Application for Works Approval

Works Approval Number W2997/2025/1

Premises Andy Well Gold Project
Mining Tenement M51/870
MEEKATHARRA WA 6642

Date of report 08/01/2026 – FINAL

Figure 3: Existing monitoring bore locations

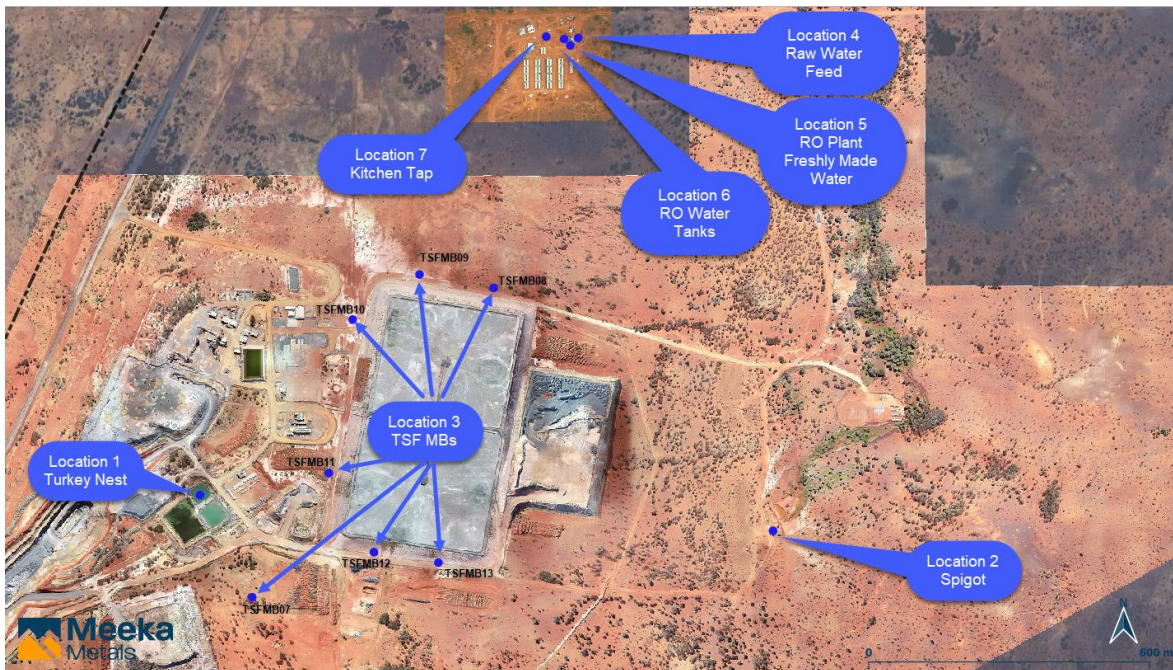
There are currently a series of monitoring bores around the existing TSF that provide ongoing groundwater quality monitoring in line with the conditions of the licence L8698/2012/1. With the construction of the TSF 3, existing bores TSFMB8 -11 will remain in place. Bores TSMB7,

TSMB12 and TSMF13 will be lost in the construction of TSF 3 (see Figure 3).

Figure 4: Additional bore monitoring locations (in dark green)

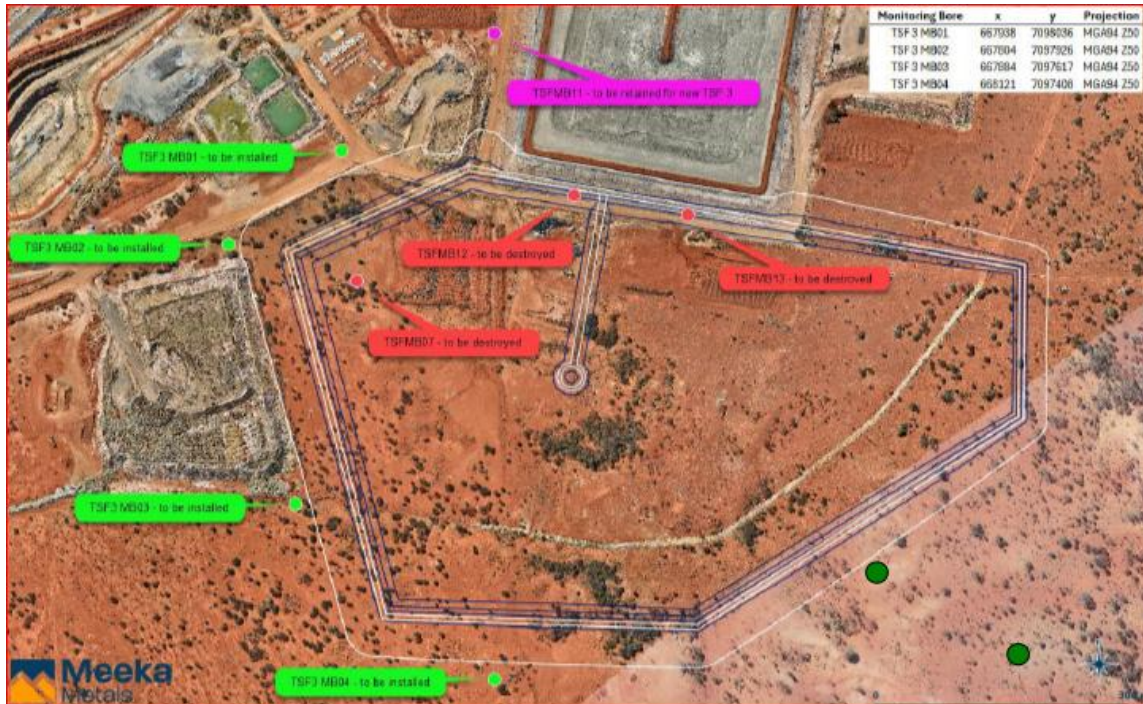
The four new bores (TSF3MB01 – 04) will be installed at the southern end of the TSF 3 to allow this area to be investigated. CSB considers the proposed locations of the replacement bores are reasonable, but it is not known whether they have been specifically located in the vicinity of bedrock structural features that are potential conduits for groundwater flow.

In addition to the proposed monitoring bore sites, the department requires two additional monitoring bores (TSF3MB05 and TSF3MB06) to be installed near TSF 3 to the south east (see Figure 4 below) to provide information about the natural background quality of groundwater in the area.

This is considered to be necessary, as groundwater quality data that was provided in reports that were reviewed by CSB indicated that concentrations of some metal(loid)s were elevated above concentrations that are naturally measured in groundwater in the region. This is especially the case for concentrations of cobalt and selenium in groundwater, although concentrations of these chemical constituents are not currently at levels that are considered to be harmful to local environmental receptors.
